MONTGOMERY COUNTY HISTORIC PRESERVATION COMMISSION
STAFF REPORT

Address:	7423 Buffalo Avenue, Takoma Park	Meeting Date:	2/11/2026
Resource:	Contributing Resource Takoma Park Historic District	Report Date:	2/4/2025
Applicant:	Griffin Witte Margo Ricks (Agent)	Public Notice:	1/28/2026
Review:	HAWP	Tax Credit:	No
Permit Number:	1145919	Staff:	Devon Murtha
PROPOSAL:	Solar panel installation

Staff recommends that the HPC **approve with one (1) condition** the Historic Area Work Permit (HAWP) application:

Figure 4: The site plan (left) shows the proposed solar panel locations and the building’s relationship to the public right-of-way along Maple Avenue. The roof plan (right) shows the proposed location of the solar panels and the equipment location.

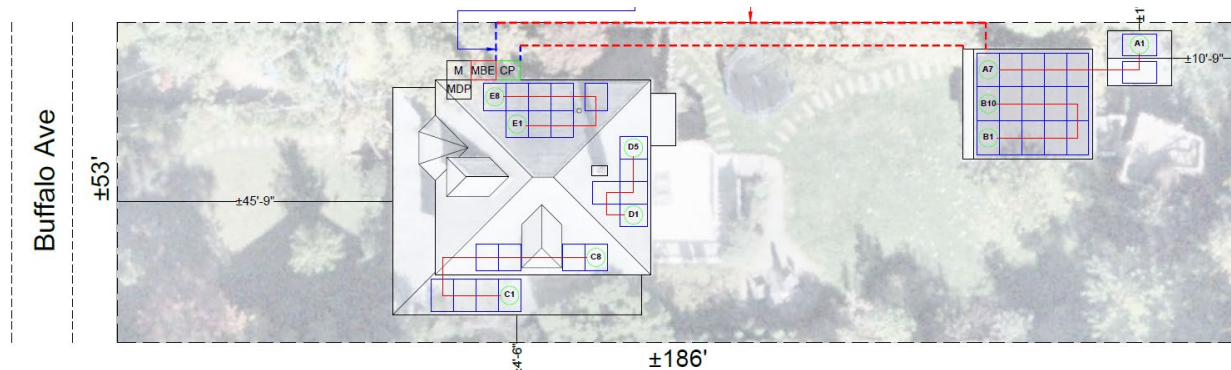
Three (3) of the arrays are located on the secondary preferred location – on the two accessory structures on the rear of the property. Staff finds that these arrays are appropriate, per the *Policy No. 20-01*.

The remaining five (5) arrays are located on the main building. Four (4) of the arrays are on the side and rear roof slopes, and none are on the front slope. Staff finds that, due to the height of the roof, the presence of dormers, and the setback of the house, many of these arrays will be not at all visible from the right-of-way along Buffalo Avenue. The arrays installed on the north/left side roof and the one array installed in front of the dormer on the south/right side roof may be minimally visible from some oblique angles, but have no impact on the overall streetscape, per the *Guidelines*. One (1) array will be installed on the side porch roof. Staff finds that due to the relatively low slope of the roof, and the placement of the panels, this array will also be minimally visible, if at all, from the right-of-way along Buffalo Avenue, and will also have no impact on the streetscape, per the *Guidelines*.

1. The panels must be installed to be no taller than six (6) inches above the roof.

Figure 5: Specifications for the solar panels.

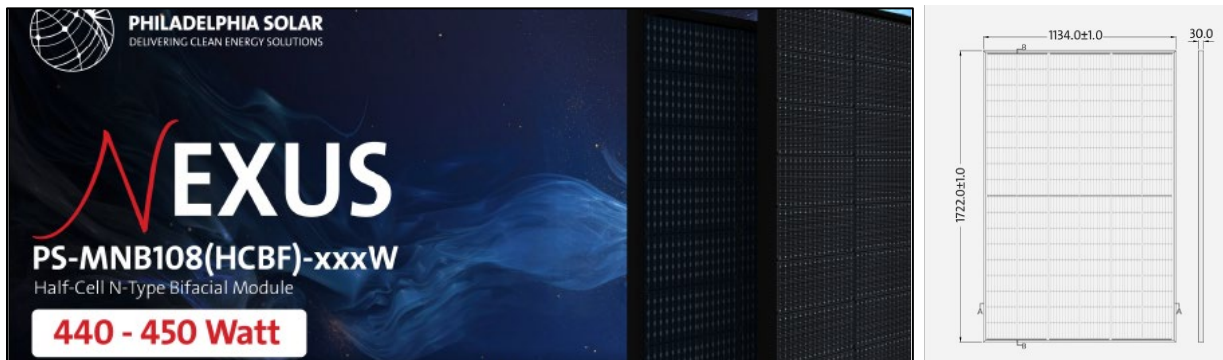
Per *Policy 20-01*, the roof is neither architecturally significant, nor is it slate or tile. Staff finds that the panels arrangements are generally designated to be installed in an orderly manner, although the specific roof conditions call for the configuration of many, smaller arrays. Staff notes that the panels should not be installed to be taller than six (6) inches higher than the roof, per the installation guidance provided with the Illustrated Design Guidelines for *Policy No. 20-01*.¹
